**SUBJECT:** Information in Preparation for Special Meeting for the Cedar Street Reconstruction Preliminary Design

CEDAR STREET RECONSTRUCTION  
CITY OF SANDPOINT, ID

75% REVIEW  
DOCUMENTS

ROADWAY OVERALL PLAN

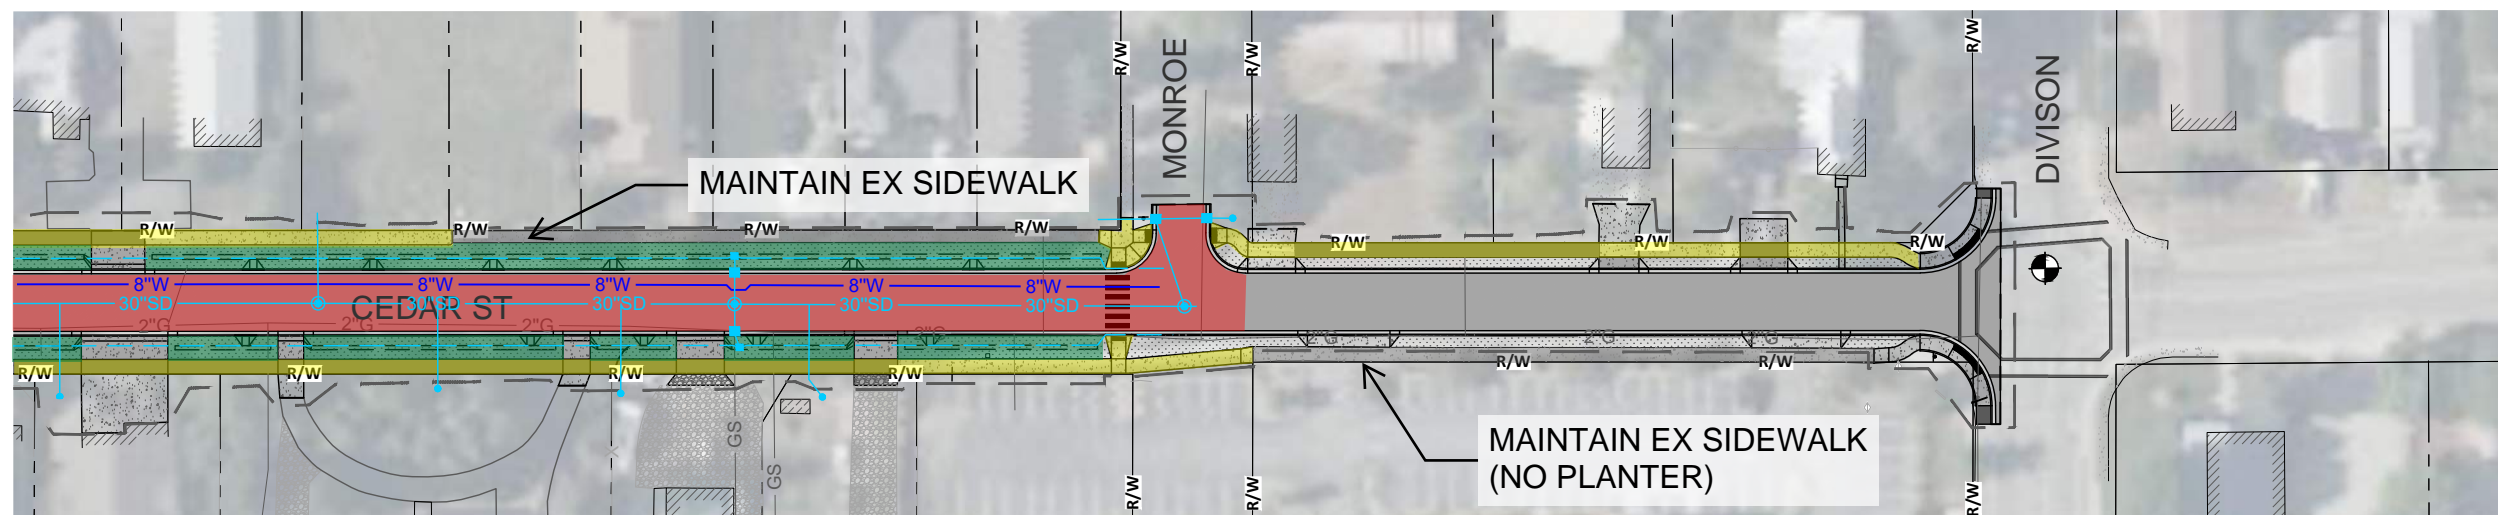
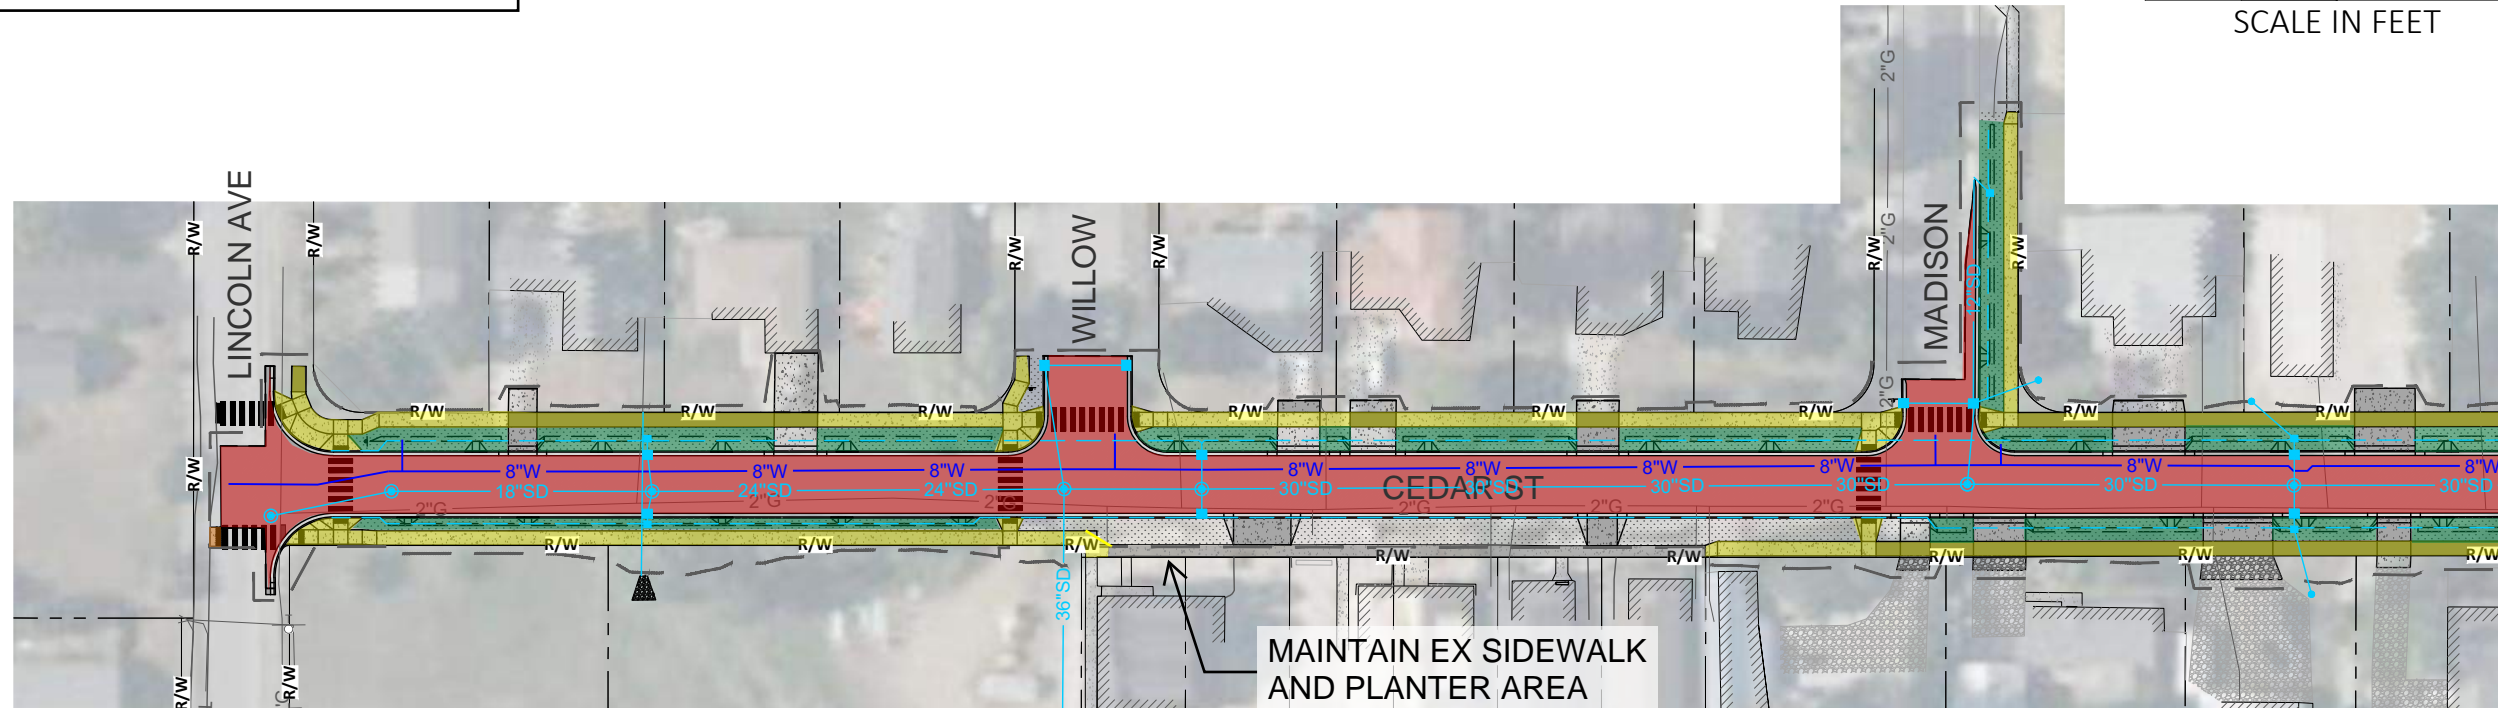
I recommend a 32' paved section (not 24') to provide two 12' travel lanes and one 8' on street parking lane; sidewalk and planting strip along south side only (a sidewalk/planting strip on north side is redundant).

I recommend that a 32' wide paved section be provided in order to accommodate on-street parking. A 24' wide paved section has been designed which will not accommodate on-street parking. One, 8-foot wide parking lane will at least provide some on-street parking. Note that when a vehicle is currently parked on-street, two vehicles cannot pass. (Cedar Street currently averages about 24 feet in width.) Emergency vehicle access is restricted. I further recommend that this additional paved section width be designed in lieu of the redundant north side sidewalk and planting strip. A south side sidewalk and planting strip is already proposed. A north side sidewalk and planting strip across the street from the proposed south side sidewalk and planting strip is not necessary, is impractical and is not as critical as is a wider paved section to accommodate some on-street parking.

Based on your practical suggestions and my need to temporarily occupy the right of way as noted, it would make sense to position the north curblin an additional 8' north of the alignment shown on the draft plans set and expand the pavement section from 24' to 32' to the north along the south boundary of my lot. You mentioned widening this paved section not just in front of my lot, but perhaps for the entire block between Willow Drive and Lincoln Ave. This makes *more* sense than only widening the paved section in front of my lot. Stormwater can simply be hard piped along this widened paved section as it is presently, and as it is shown on the plans set.

1. A 32' wide paved section adjacent to and in front of my lot (or the entire block as you see fit); and
2. An 18' wide driveway from the north right of way boundary to the face of my garage and the construction limits revised accordingly.

DEMOLITION OVERALL PLAN

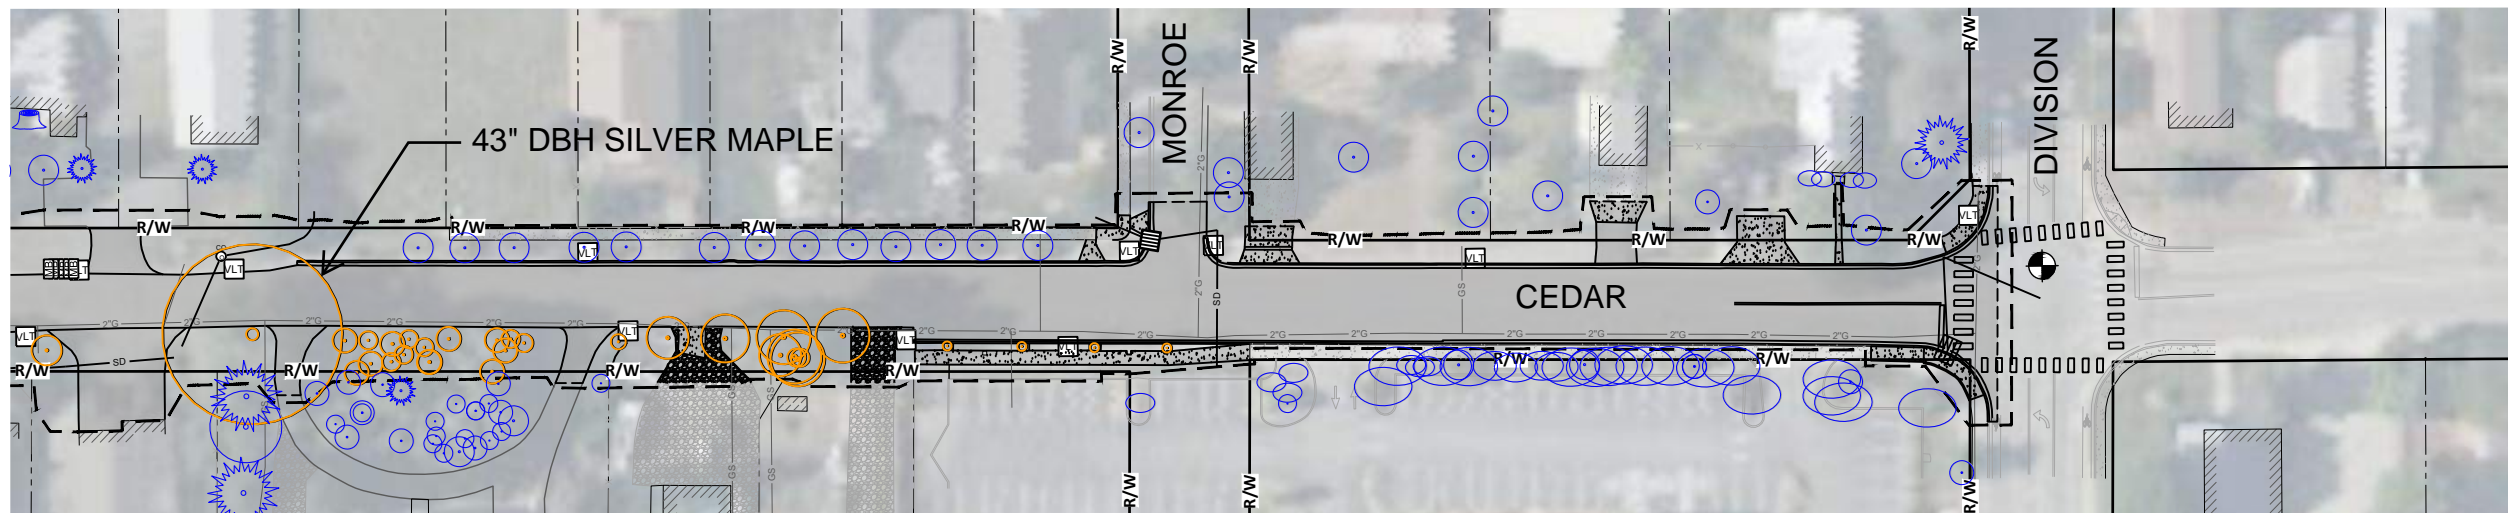
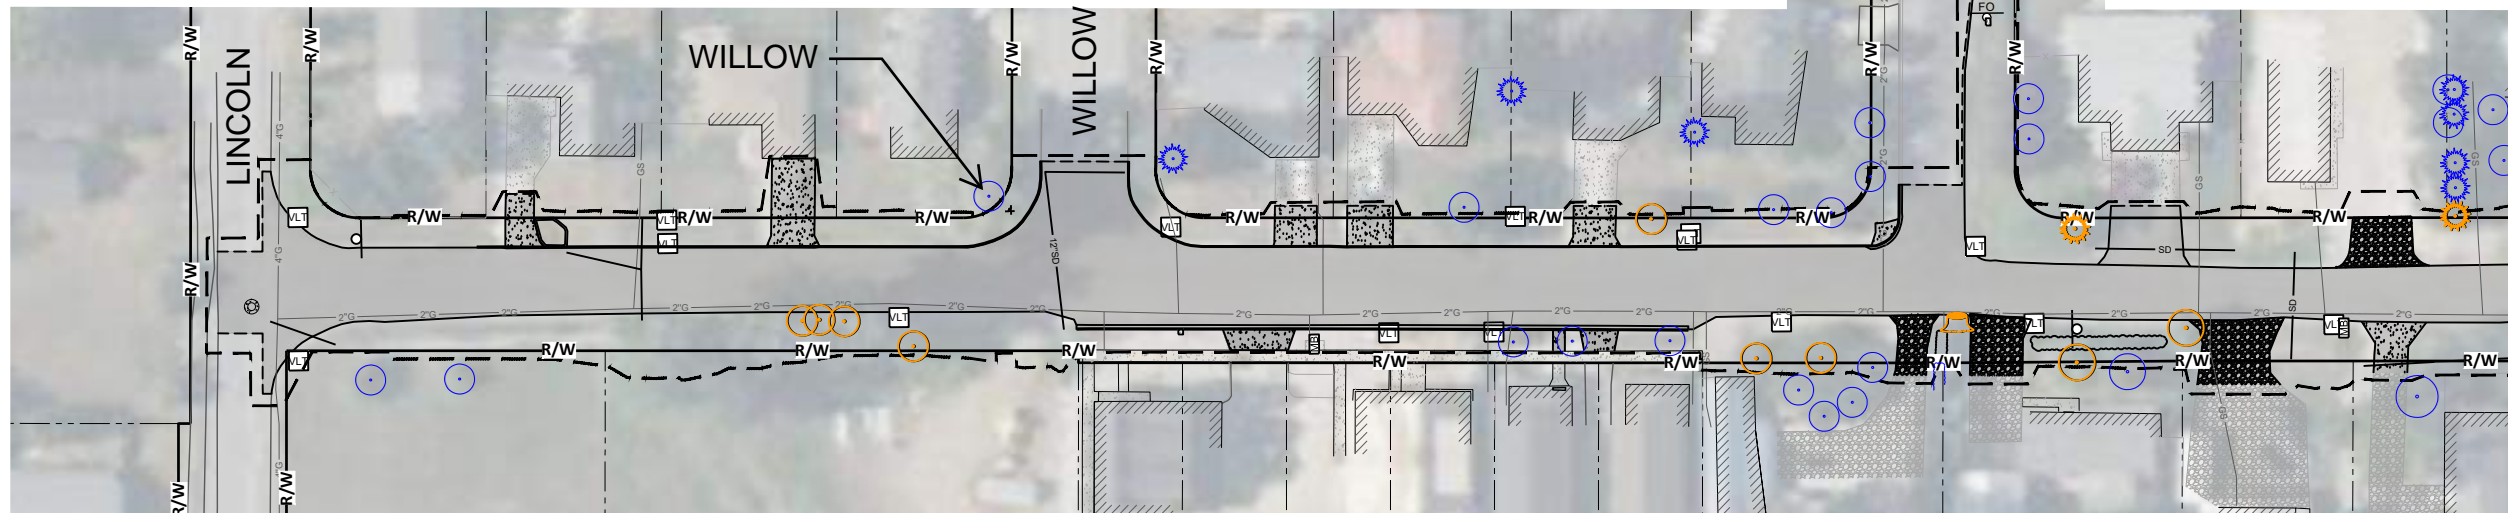
Forestry Commission expressed the importance of preserving the large silver maple located on the south side of Cedar Street between Madison and Monroe.

Cedar green ROW & other trees to remain. Rec protection plan be included in contract docs. Boul. Ground cover, consider xeriscape for lawn maintenance long term.

Staff evaluated tree preservation feasibility following the City's typical tree protection practices. However, preservation was deemed infeasible due to the inability to shift the roadway alignment sufficiently to prevent excavation within the Critical Root Zone (CRZ), the shallow root system characteristic of silver maples, the requirement for road profiles to be free of organic material to prevent settlement, the long-term stability risks if significant roots are cut, the high cost of tree protection measures, anticipated to exceed \$10,000 due to potential root disturbance and soil compaction risks. Sandpoint's adopted Urban Forestry Management Plan notes, "An American Forests article published in the early 80's stated that an oak or maple tree is capable of living up to 400 years in the forest, up to 80 years on a college campus, up to 30 years in a heavily used park, up to 20 years along a city street and about 4 years in a downtown planting pit".

If tree preservation remains a priority, a protection plan must be implemented to maximize the chances of maintaining the tree while allowing necessary road reconstruction. Regular monitoring and adaptive management will be essential for long-term tree health. Tree protection measures would be prescribed by the engineer and a certified arborist and may include the following measures:
